Town of Simsbury

RE: Application CC #23-26 of 894 Hopmeadow Street, LLC, Owner, Charles Houlihan, Applicant, for a wetland permit to fill +/-3,229 sq. ft. and other site disturbance within the wetland soils and associated activity in the upland review area for the construction of a +/-53,773 sq. ft. mixed-use residential building at 894 Hopmeadow Street, (Assessor's Map H09, Block 227, Lot 004A) Simsbury, CT 06070, zone SC-1.

DESIGN REVIEW MEMORANDUM

Subject: **Engineering Comments – Proposed Redevelopment
#894 Hopmeadow Street**

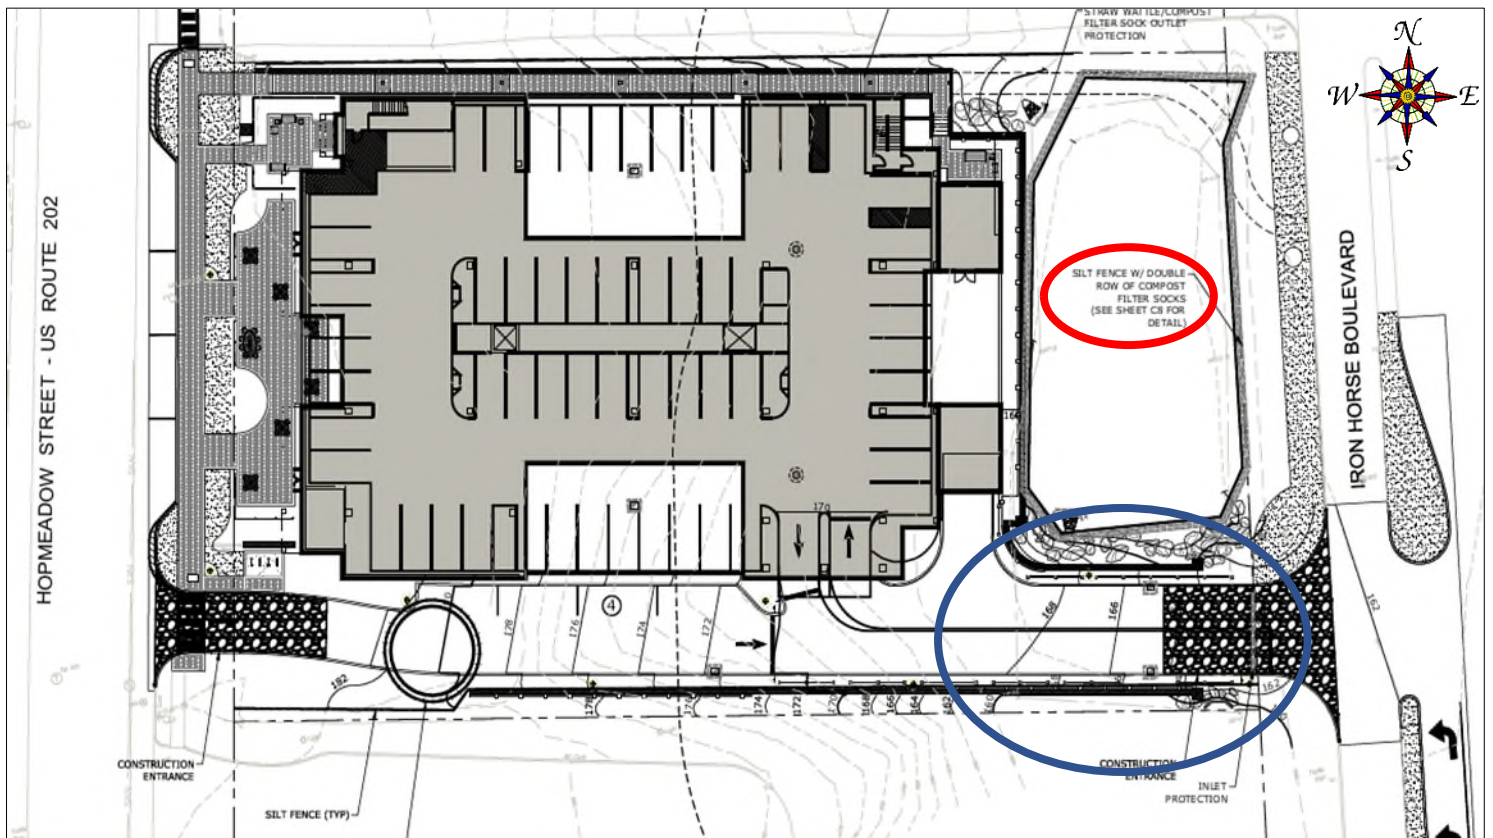
The plan requires the filling of approximately 3,223 s.f. of the southern portion of the wetland soil area to provide access to the site from Iron Horse Boulevard, which is shown approximately within the blue circle on the map below. Due to this activity, approximately 33% of the wetland soils will be permanently altered.
